REGULATION No. 48  
(Installation of lighting and light-signalling devices)

Clarifications on installation requirements

Proposal for draft Supplement 5 to the 04 series of amendments to Regulation No. 48

Submitted by the expert from Germany \*/

Figure 1

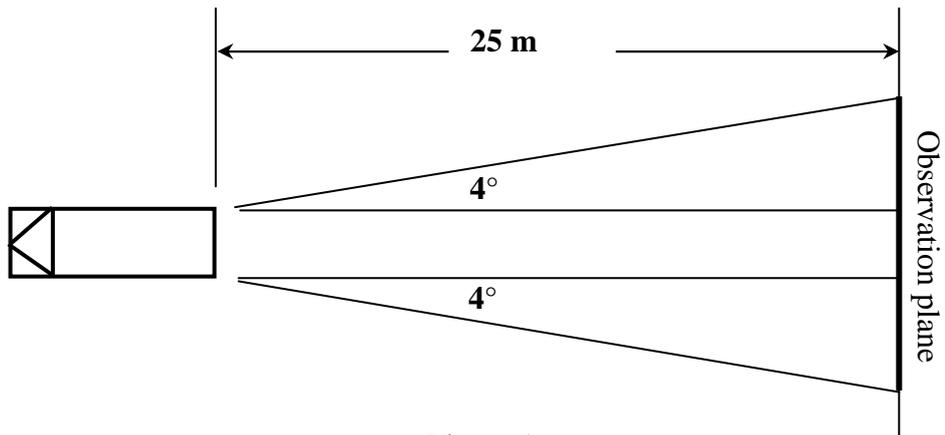
6.21.5.1. for rear conspicuity markings (see Annex 11, Figure 1) the observation plane is perpendicular to the longitudinal axis of the vehicle situated **25 m** from the extreme end of the vehicle and bounded by:

6.21.5.1.1. in height, by two horizontal planes 1 m and 3.0 m respectively above the ground,

6.21.5.1.2. in width, by two vertical planes which form an angle of **4°** outwards from the vehicle's median longitudinal plane and which pass through the intersection of the vertical planes parallel to the vehicle's median longitudinal plane delimiting the vehicle's overall width, and the plane perpendicular to the longitudinal axis of the vehicle that delimits the end of the vehicle.

Figure 2

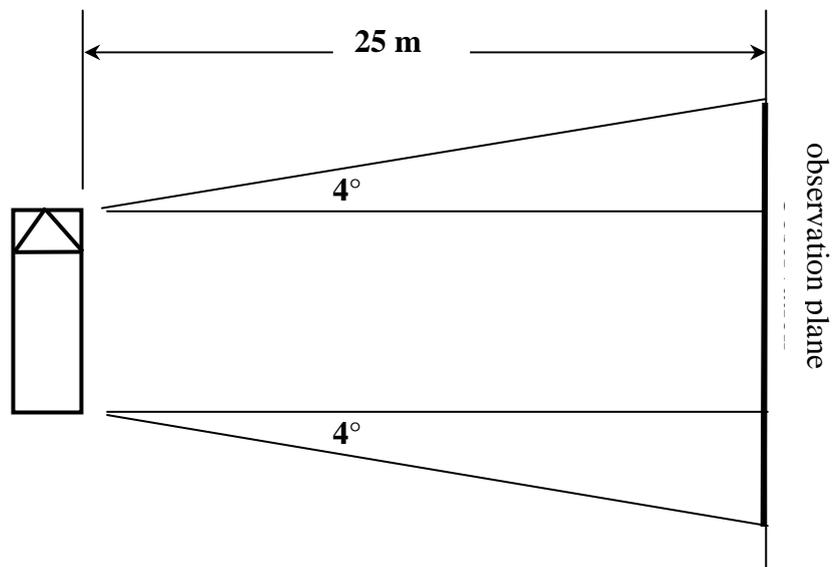
6.21.5.2. for side conspicuity markings (see Annex 11, figure 2) the observation plane is parallel to the longitudinal median plane of the vehicles situated **25 m** from the extreme outer edge of the vehicle and bounded by:

6.21.5.2.1. in height, by two horizontal planes **1.0 m** and **[1.5 m]** respectively above the ground,

6.21.5.2.2. in width, by two vertical planes which form an angle of **4°** outwards from a plane perpendicular to the vehicle's longitudinal axis and which pass through the intersection of the vertical planes perpendicular to the vehicle's longitudinal axis delimiting the vehicle's overall length and the extreme outer edge of the vehicle."
